FJC | Melrose Park South - East Precinct Block 6 - SSDA Drawing Set Response to Submissions (RTS)

MELROSE PARK SOUTH | EAST PRECINCT BLOCK 6
DARUG
MELROSE PARK - BLOCK B6
MELROSE NSW 2114

Sheet No. Rev
6001 C

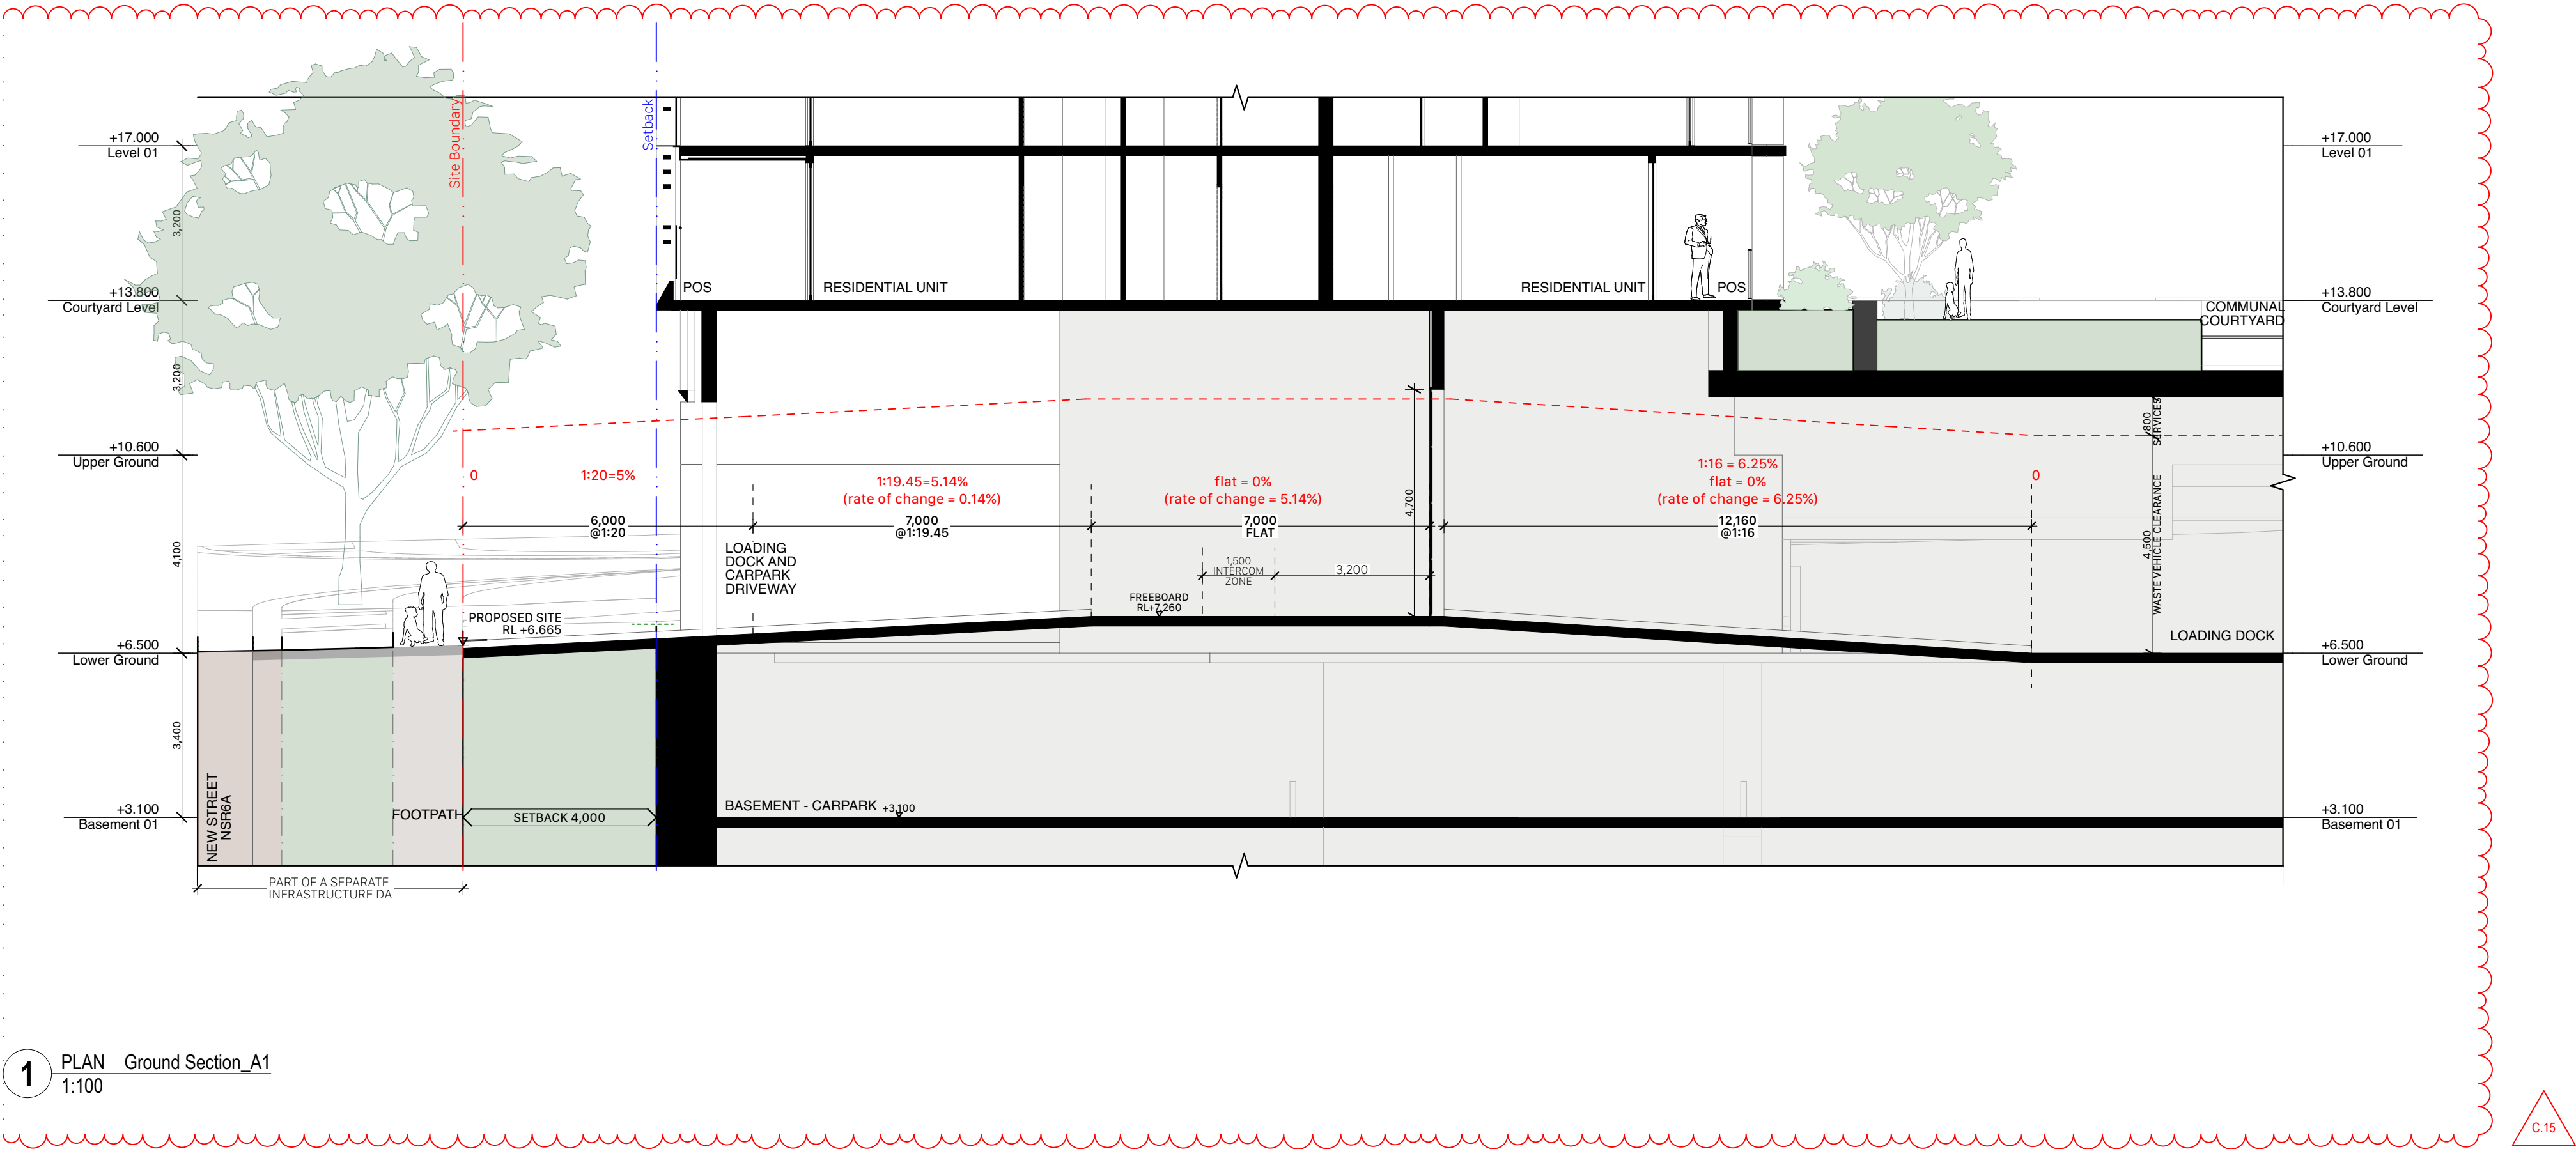
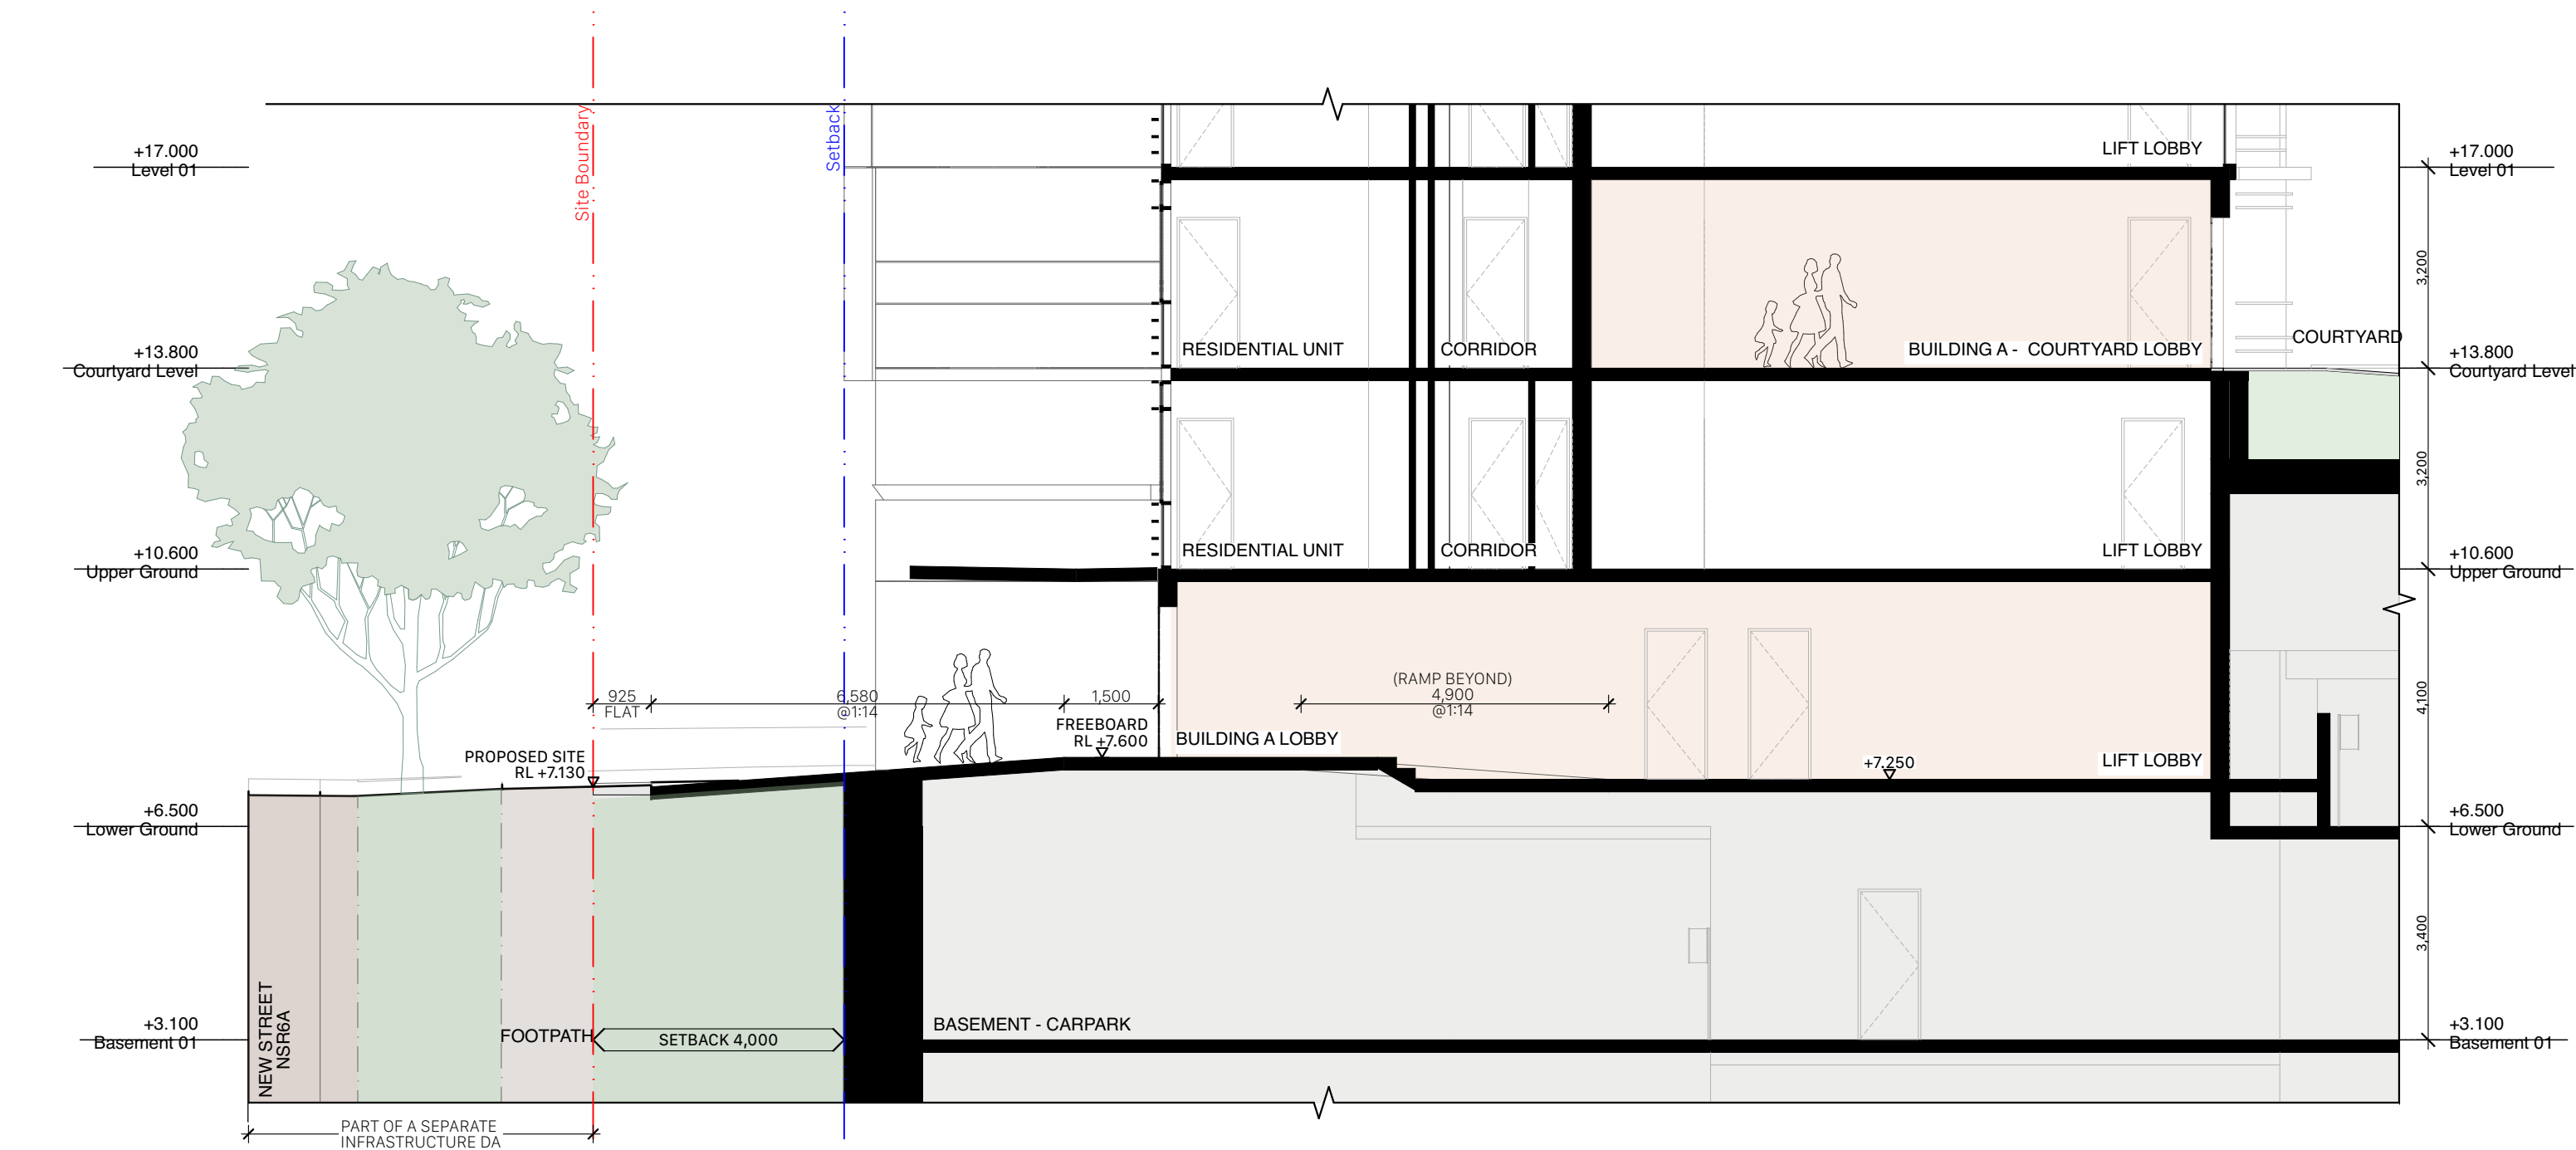
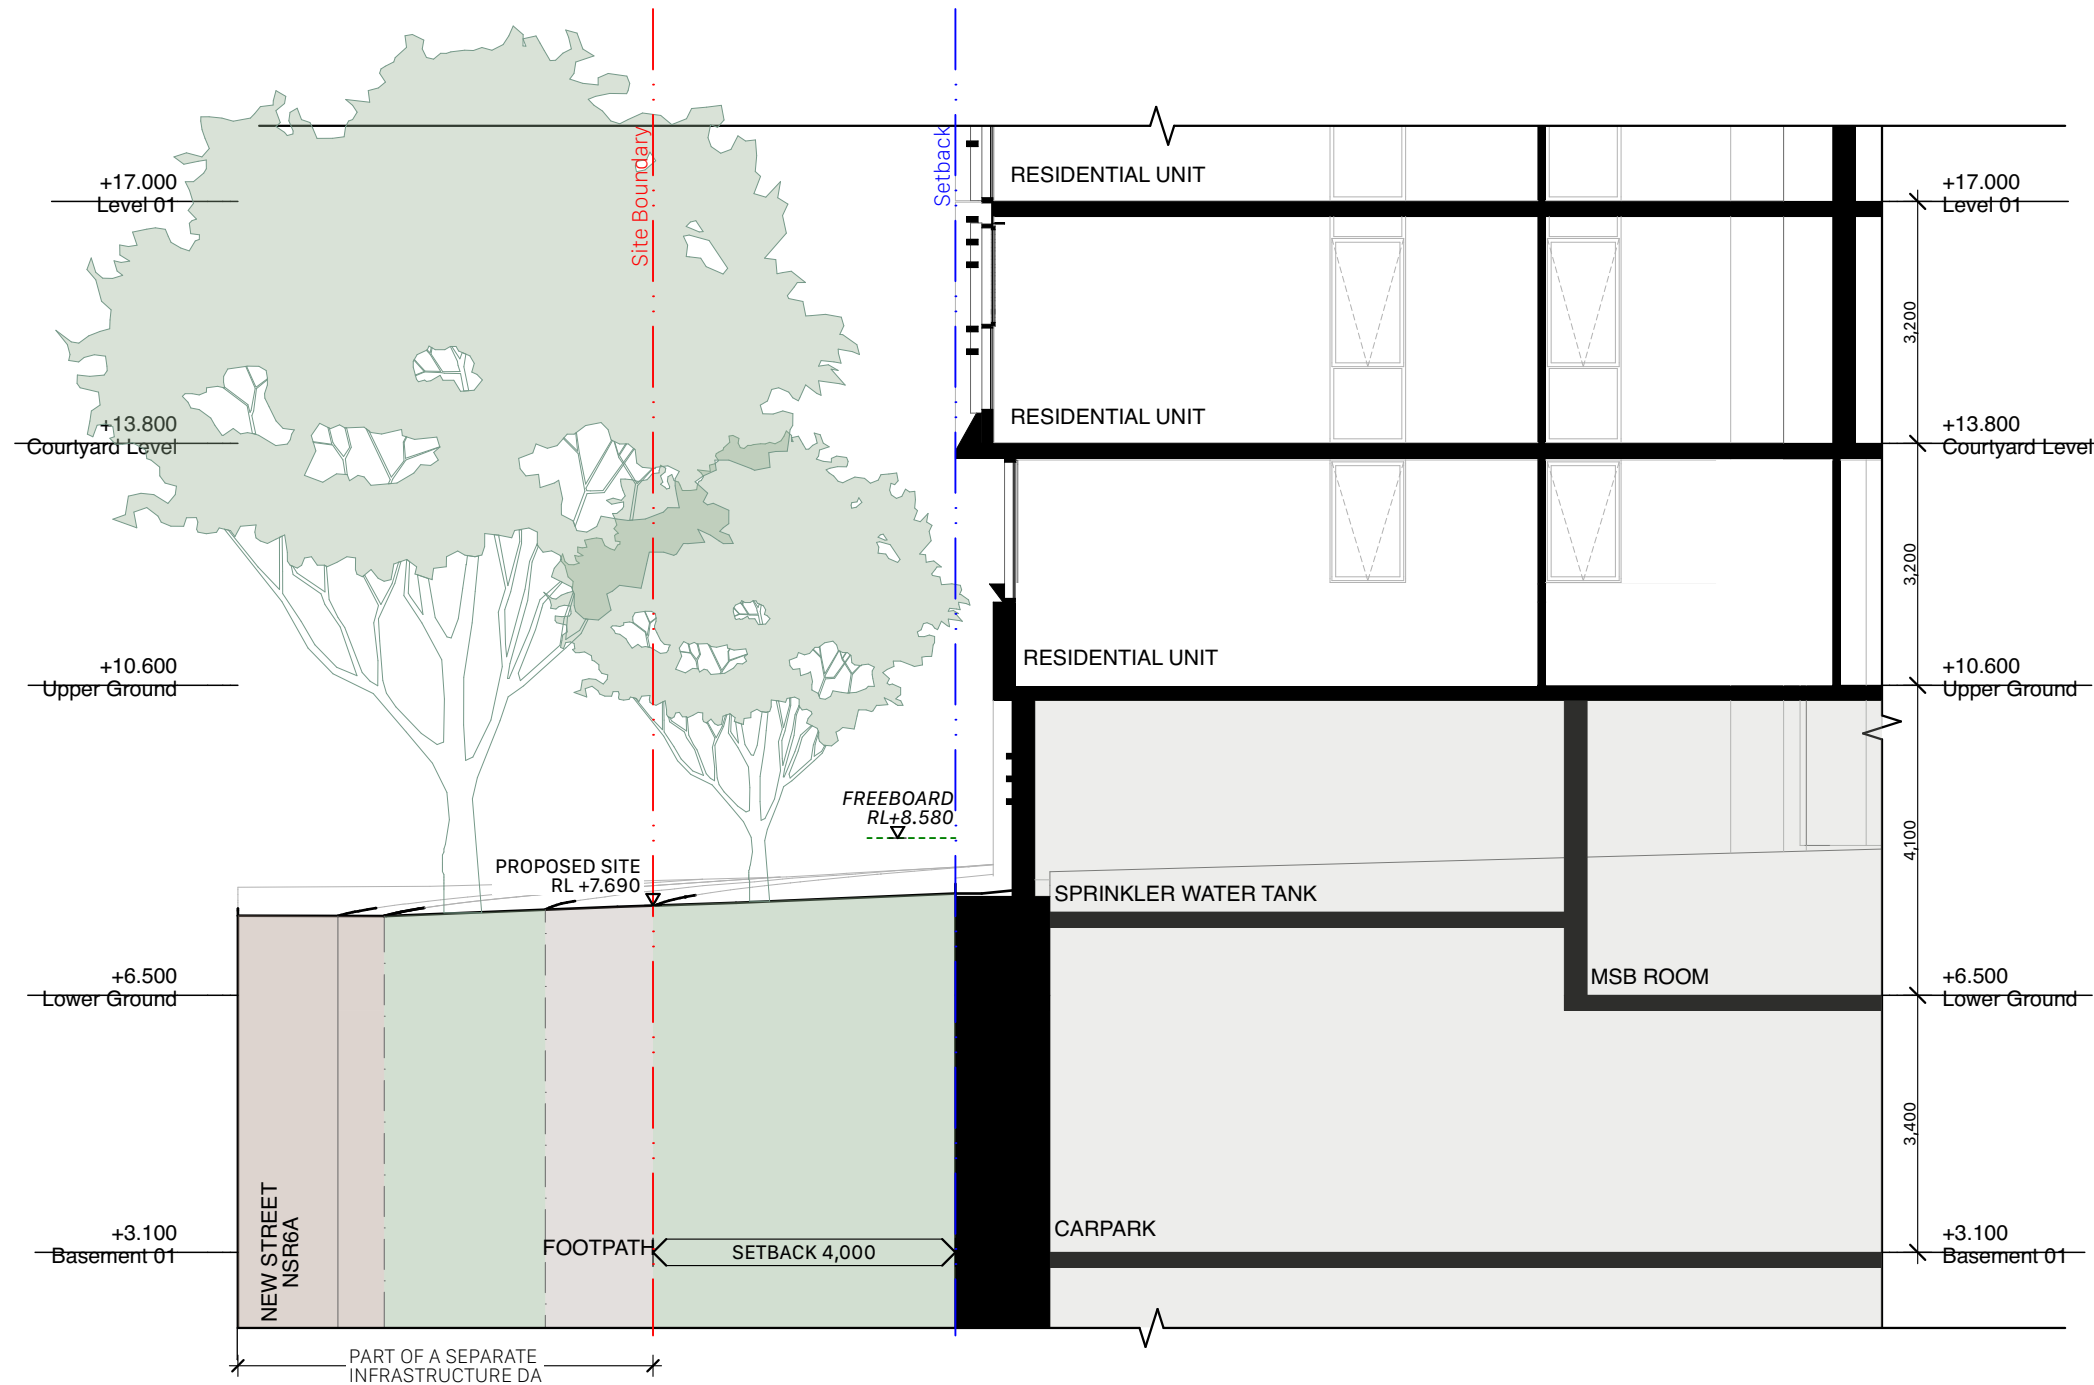
DETAILED SECTION DRAWING UPDATED:

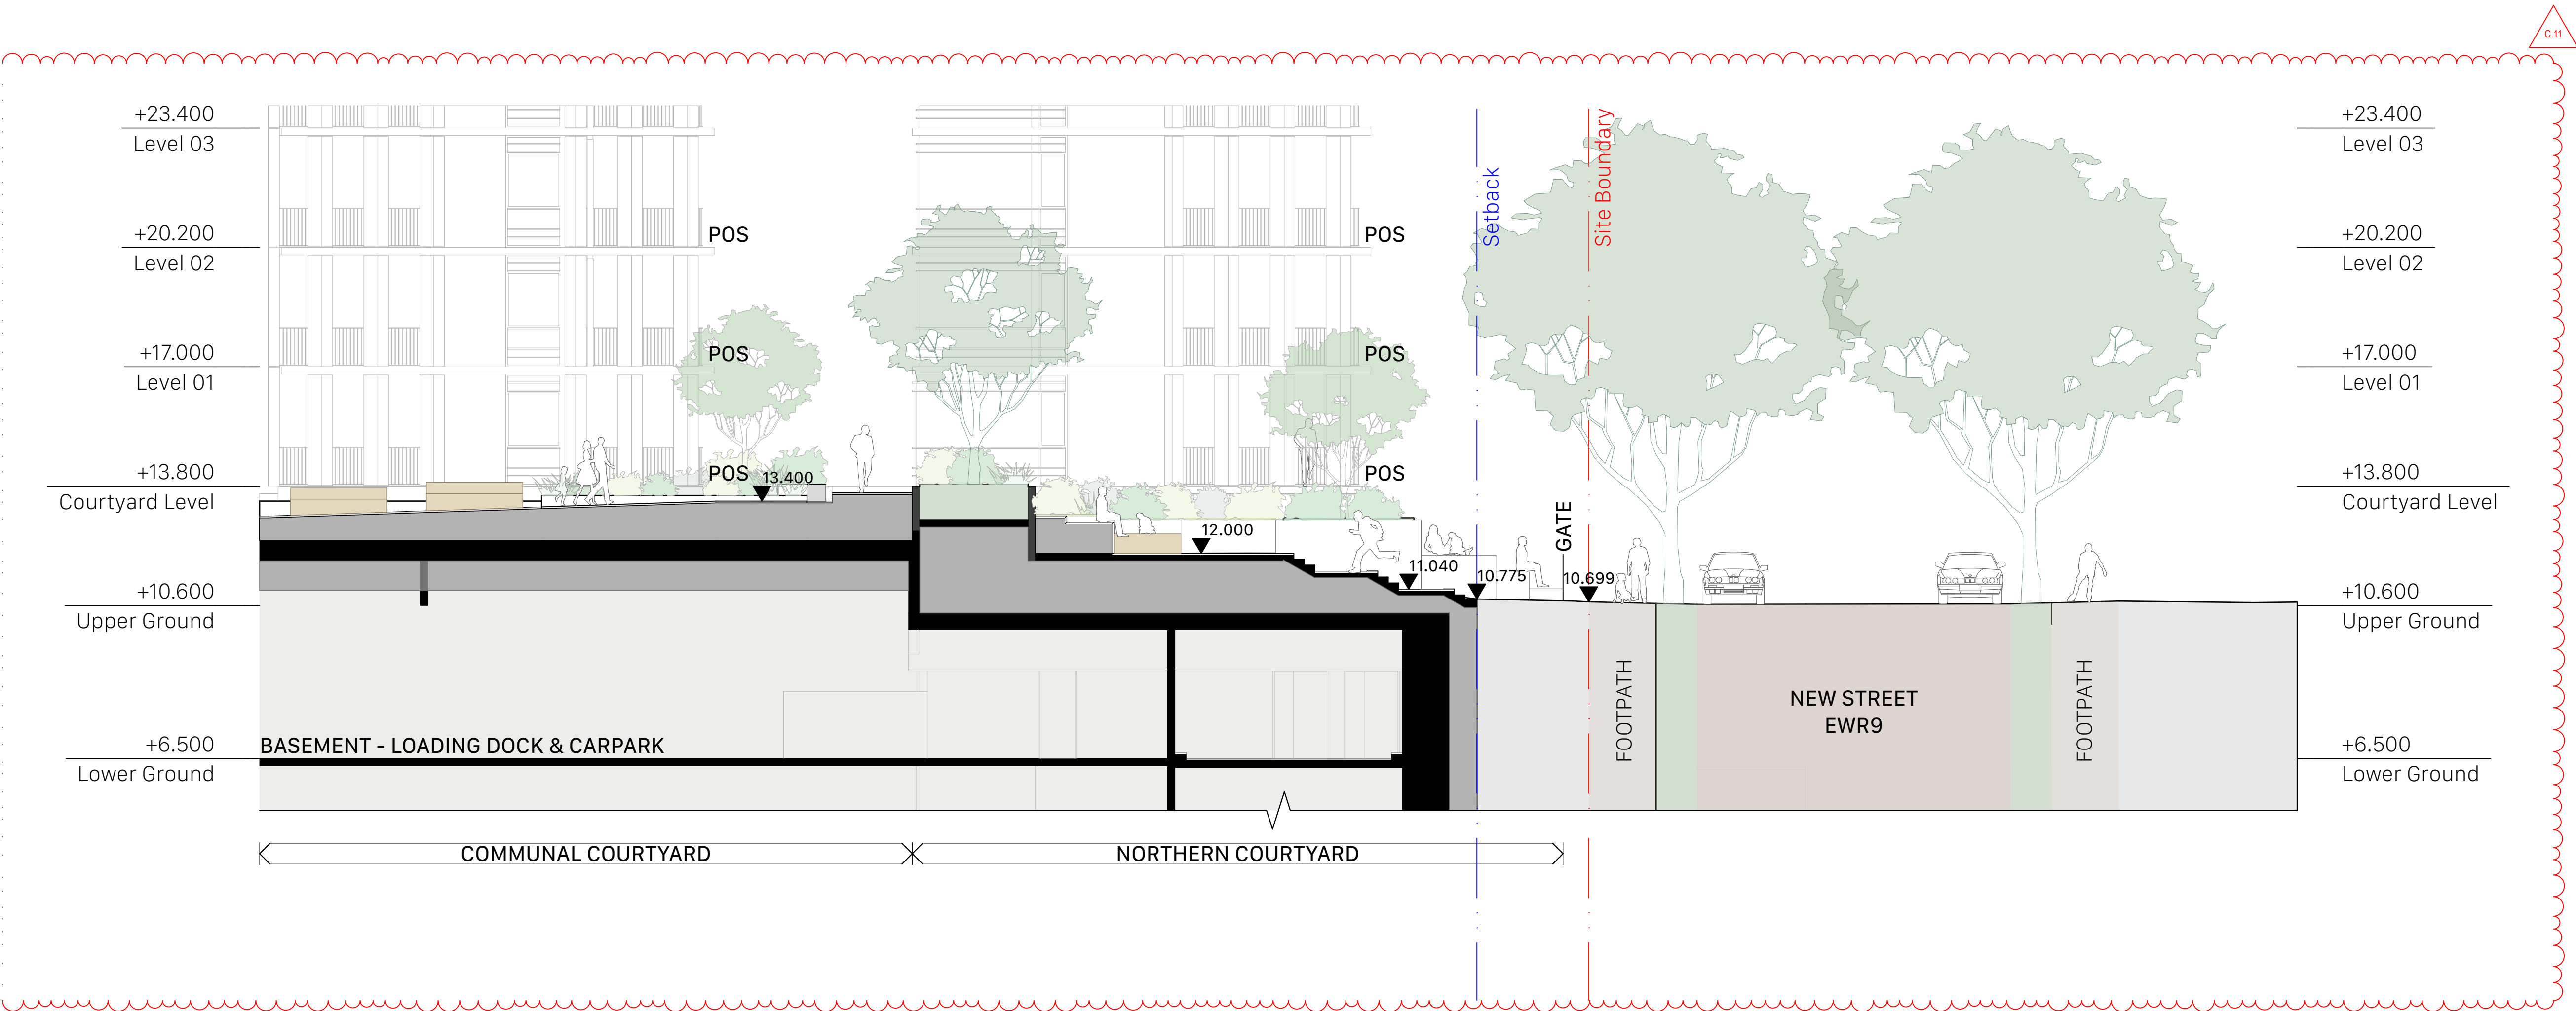
SUMMARY OF CHANGES (RTS)
